**From:** Stephen Ballinger  
**Sent:** 25 January 2021 07:36  
**To:** 'Helen Webster'  
**Cc:** 'Paul Barker'  
**Subject:** RE: ADDITIONAL INFO TO ACTION - NYM/2020/0945/LB & /0944/FL

I am attaching amended drawings showing the removal of the proposed dormer window to the north elevation, and its replacement with a conservation rooflight:

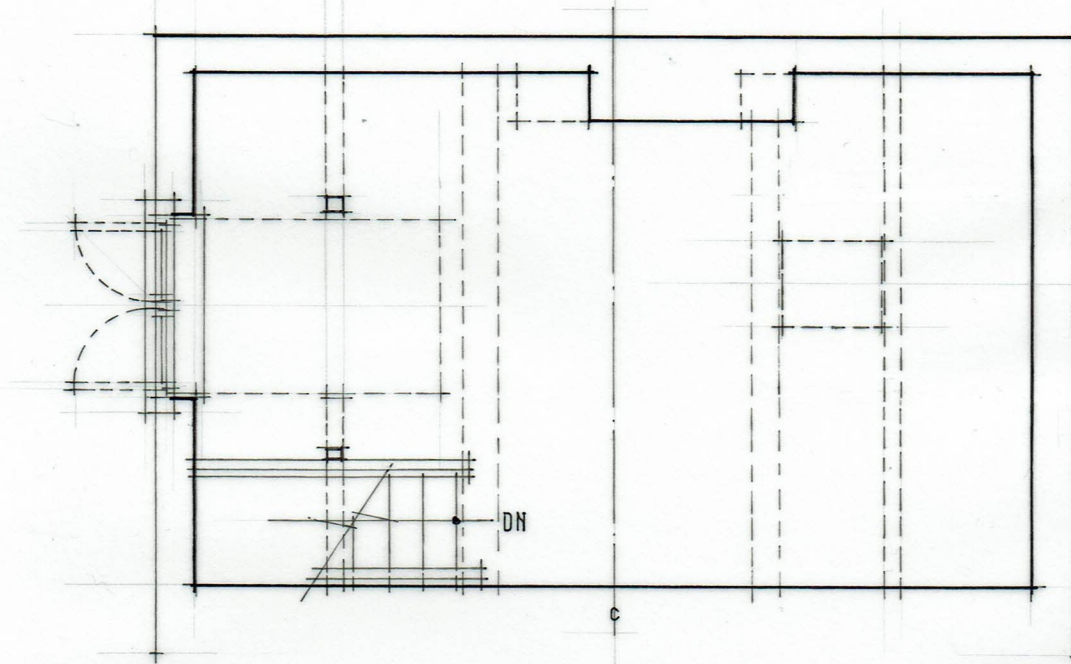
The drawings show the *CR07-2 Between the Rafter* roof window manufactured by The Conservation Rooflight Company:

The structural dimensions are 583mm width x 882mm length. The top-hinged window would be framed out within the rafter line and neatly between the existing retained upper and lower purlins. The standard frame is of 3mm mild steel, with a polyester powder coating and black painted finish. The manufacturer does suggest the possibility of using an alternative stainless steel, or steel treated with a hot Zinc spray coating, for any application within a coastal property.

2801.01<sup>A</sup> SECOND FLOOR PLANS  
1.50

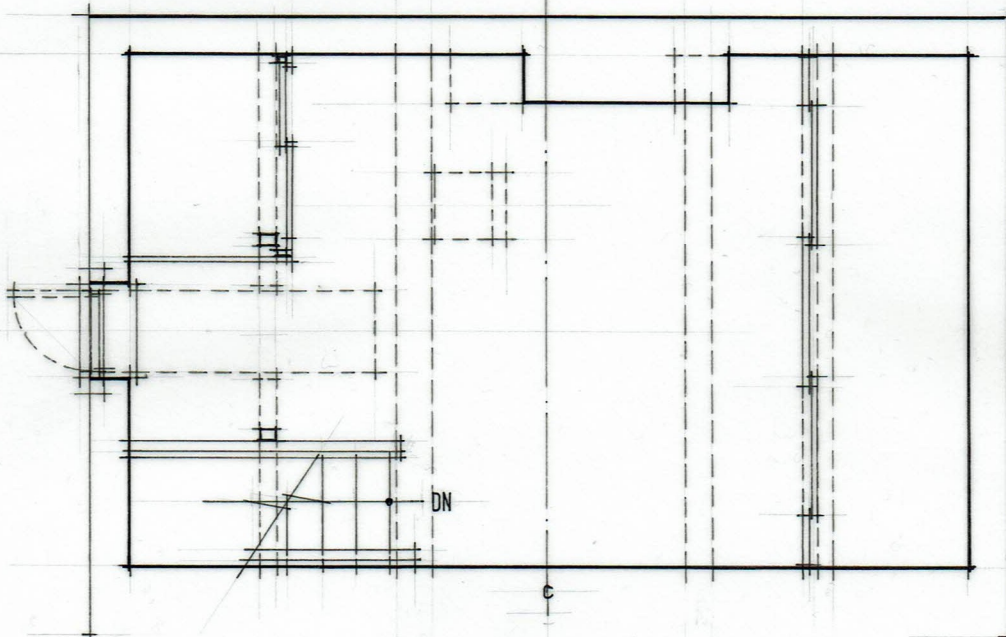
A Monday 25 January 2021.  
proposed dormer window to north side  
of W of removed. New conservation  
rooflight added.

2801.04<sup>A</sup> NORTH FRONT ELEVATIONS  
1.50

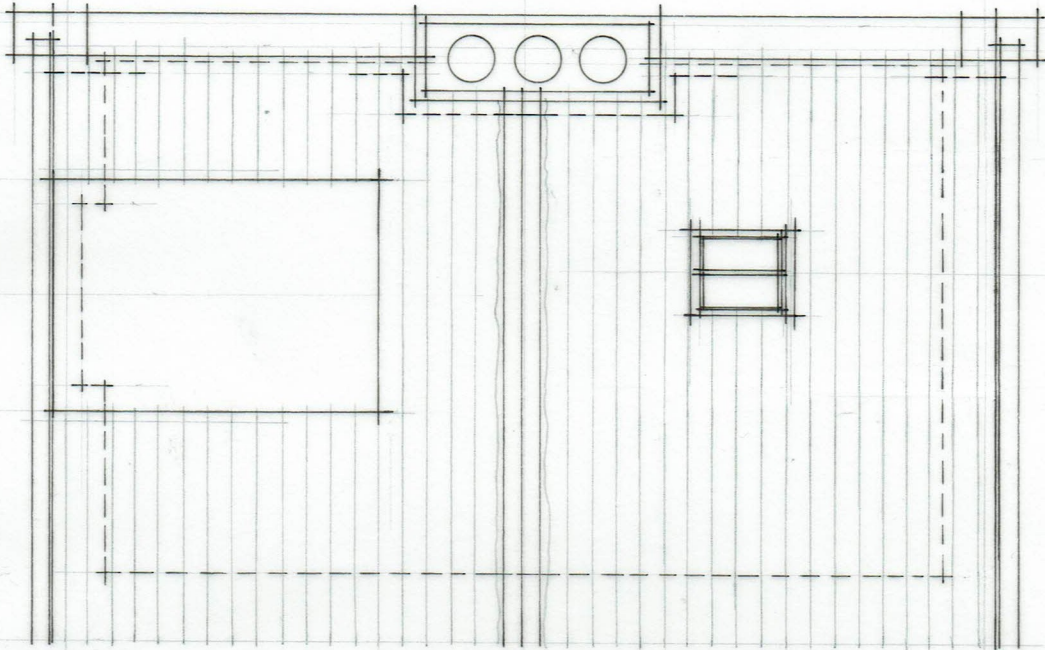
A Monday 25 January 2021.  
Proposed dormer window removed.  
New conservation rooflight added.

2801.02<sup>A</sup> ROOF PLANS  
1.50

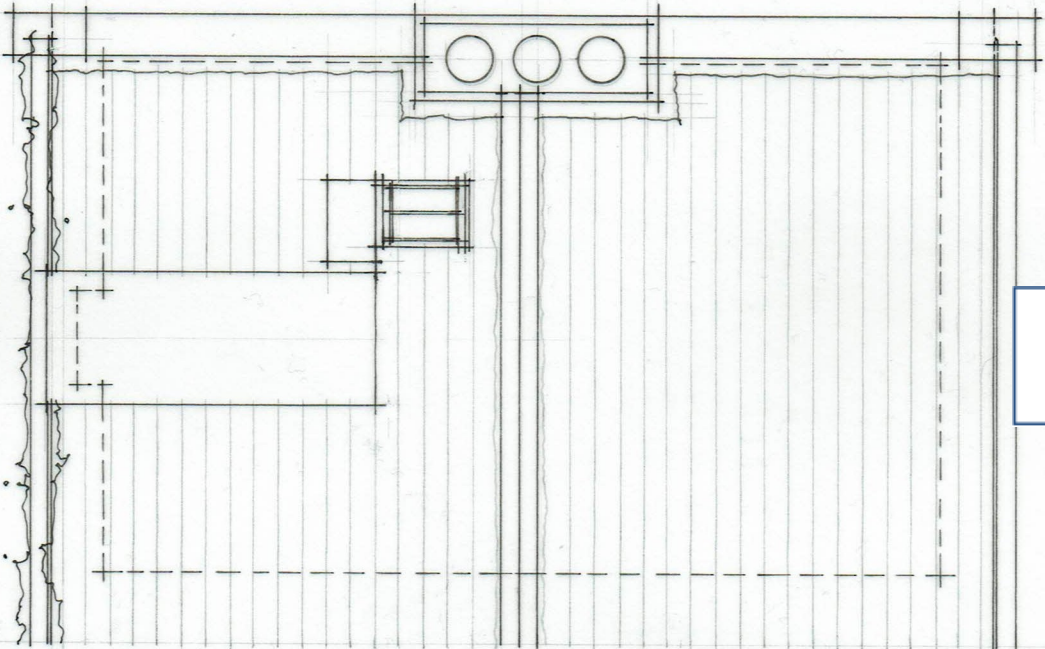
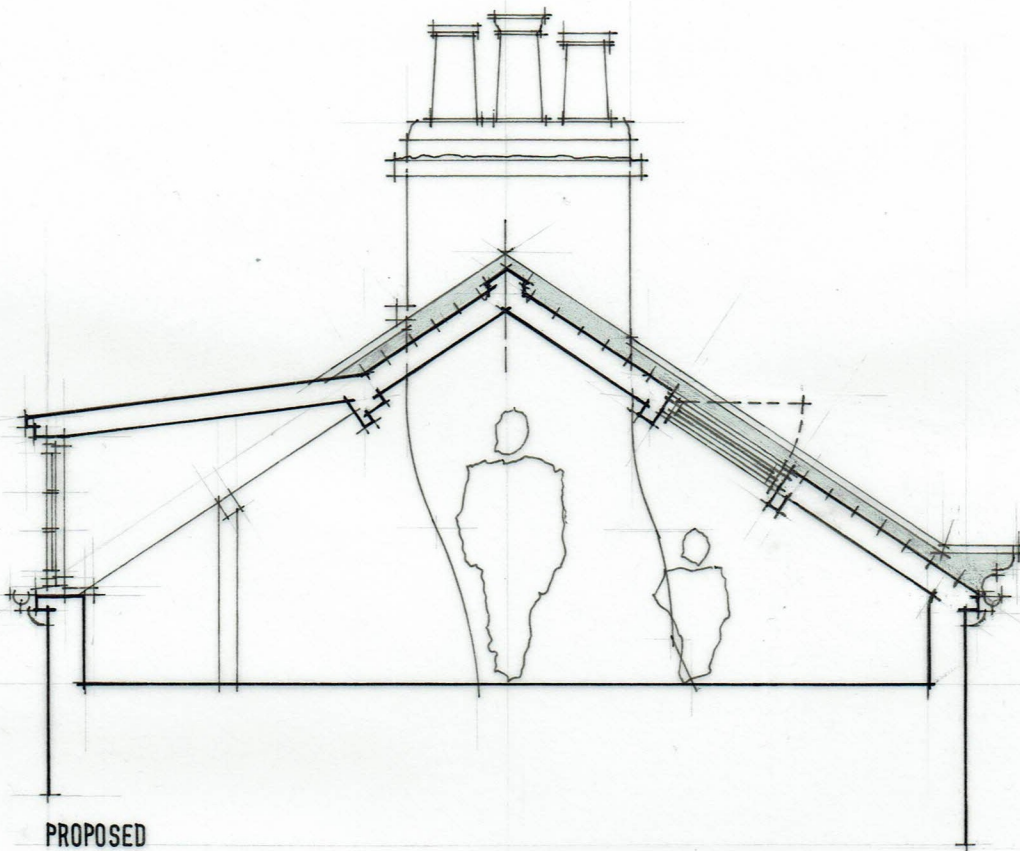
A Monday 25 January 2021.  
proposed dormer window to north side  
of roof removed. New conservation  
rooflight added.

2801.03<sup>A</sup> SOUTH-NORTH SECTIONS  
1.50

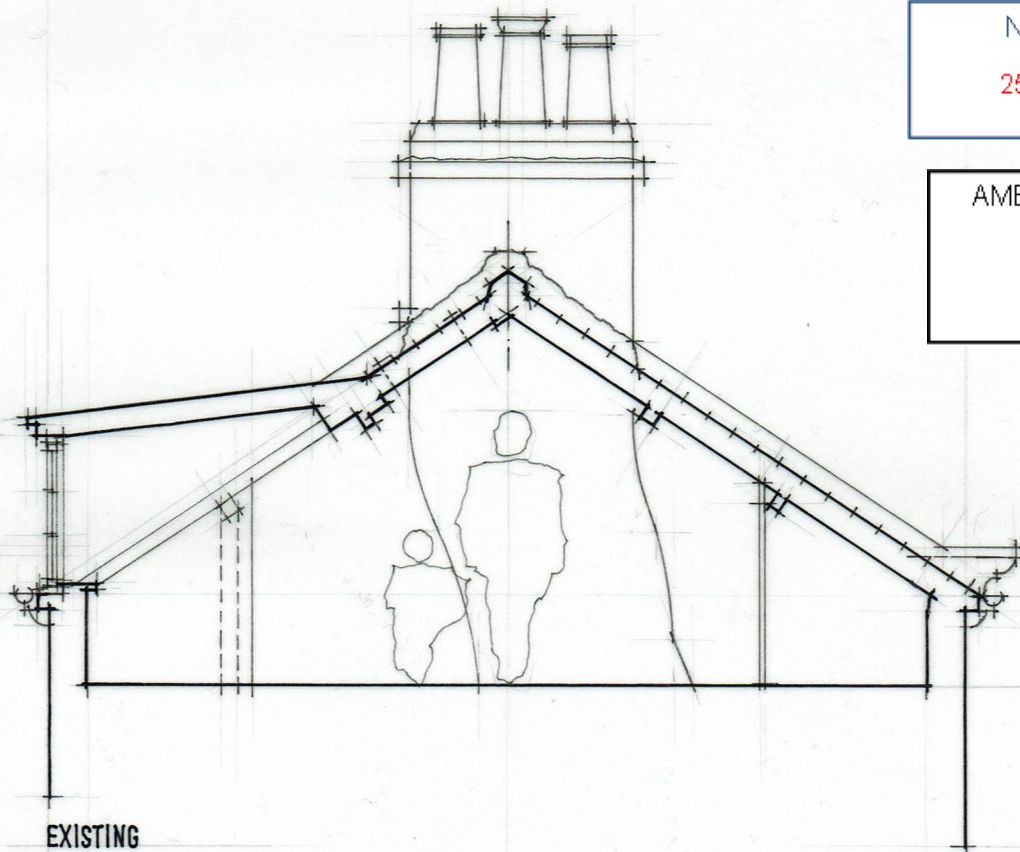
A Monday 25 January 2021.  
proposed dormer window to north side  
of roof removed. New conservation  
rooflight added.
